World Forum for Harmonization of Vehicle Regulations

Proposal for Supplement 7 to the original version of Regulation No. 85 (Measurement of the net power)

Submitted by the Working Party on Pollution and Energy*

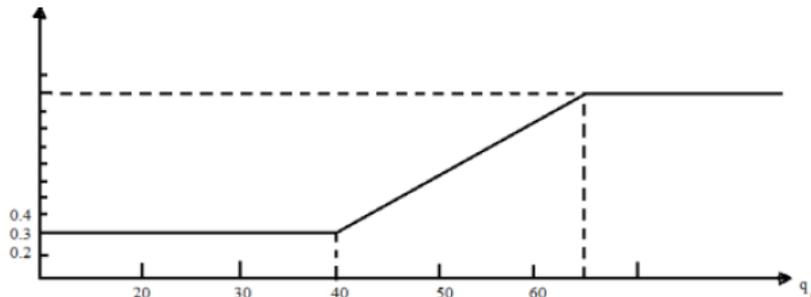
This formula is valid for a value interval of q_c included between 40 mg/(l.cycle) and 65 mg/(l.cycle.)

For q_c values lower than 40 mg/(l.cycle), a constant value of f_m equal to 0.3 ($f_m = 0.3$) will be taken.

For q_c values higher than 65 mg/(l.cycle), a constant value of f_m equal to 1.2 ($f_m = 1.2$) will be taken (see figure):

$$f_m = 0.036 q_c - 1.14$$
